**BOARD OF ZONING ADJUSTMENT  
STAFF REPORT****Date: June 2, 2014****CASE NUMBER**

5894

Jason Bunch

85 Schillinger Road North  
(Northwest corner of Schillinger Road North and Airway  
Park Drive).

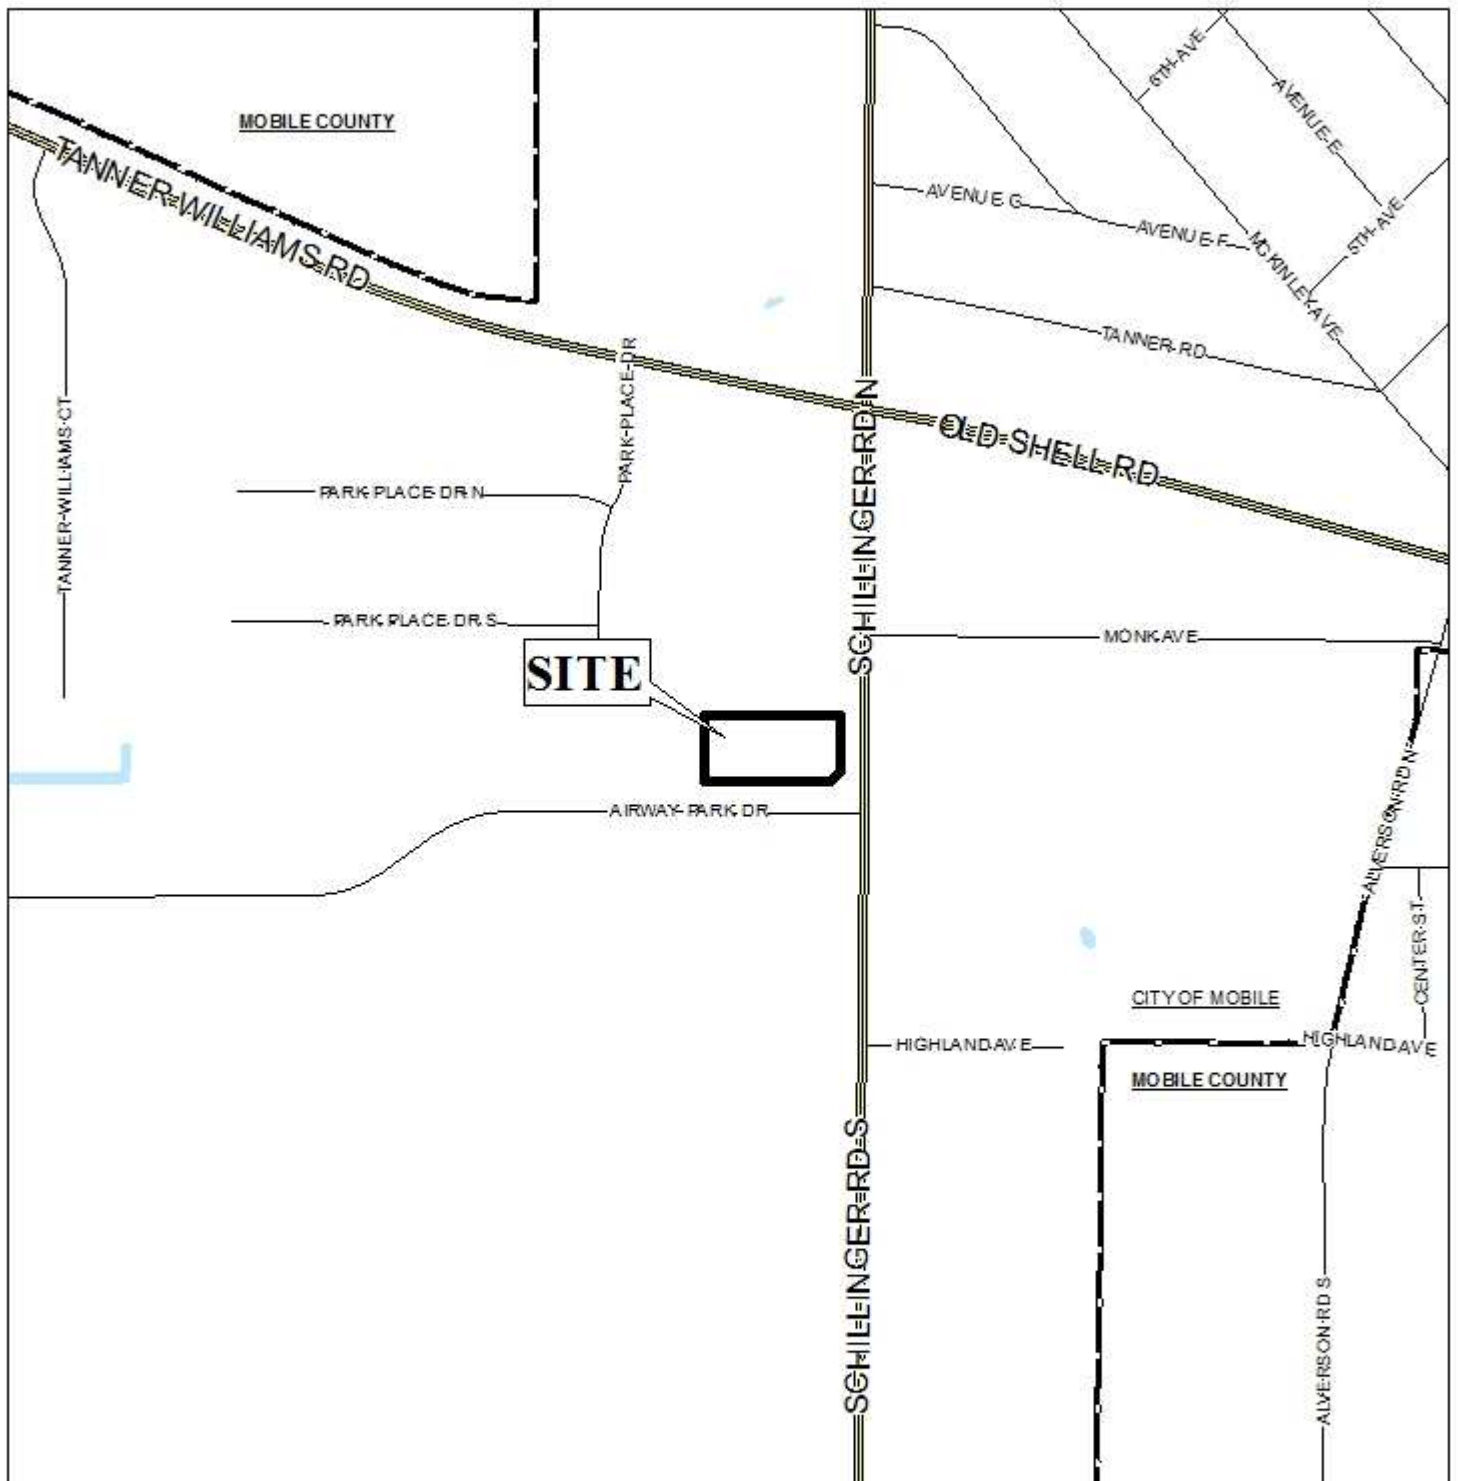
The applicant states that the lot utilized for storage of the vehicles will store approximately 30 vehicles. However, the plans submitted do not depict the number of parking spaces nor does it delineate how the cars will be stored on the property. Based upon staff’s review the site would only be able to store approximately 24 cars in accordance with the standard 9’ x 18’ dimensions and 24’ wide access aisle as required by the Zoning Ordinance.

The plan fails to illustrate any wheel stops, bumper stops, or curbing for the parking spaces as required by Section 64-6.3 of the Zoning Ordinance.

The plan also fails to depict any trees and landscaping on the site; although staff made mention of the requirements during the plan review. The applicant has failed to ask for a tree and landscaping variance as well as failed to provide tree and landscaping on the site plan which may possibly reduce the total estimated number of parking spaces. A revised site plan illustrating full tree and landscaping compliance is required, or the applicant must amend the variance application to add tree and landscaping, and provide new mailing labels, notification fees, and the additional variance fee.

The site plan does not illustrate fencing or gates on the proposed plan. If the applicant proposes to provide fencing or gates on the site, it must be depicted on the site plan. If the applicant chooses not to provide fencing or gates on the site plan, neither will be allowed.

It should be noted the site plan submitted does not show the lot line that separates the two lots. A revised site plan illustrating the lots as two separate lots is required.

- 1) revise the site plan to depict full tree and landscaping compliance, or submit a revised narrative to include a tree planting and landscaping variance and payment of associated application fees; and notification labels and notification fees;
- 2) revise the site plan to depict the property line between the two separate lots;
- 3) revise the site plan to depict the number of parking spaces and delineate how the cars will be stored on the property; and
- 4) revise the site plan to depict wheel stops, bumper stops, or curbing for the proposed parking spaces.
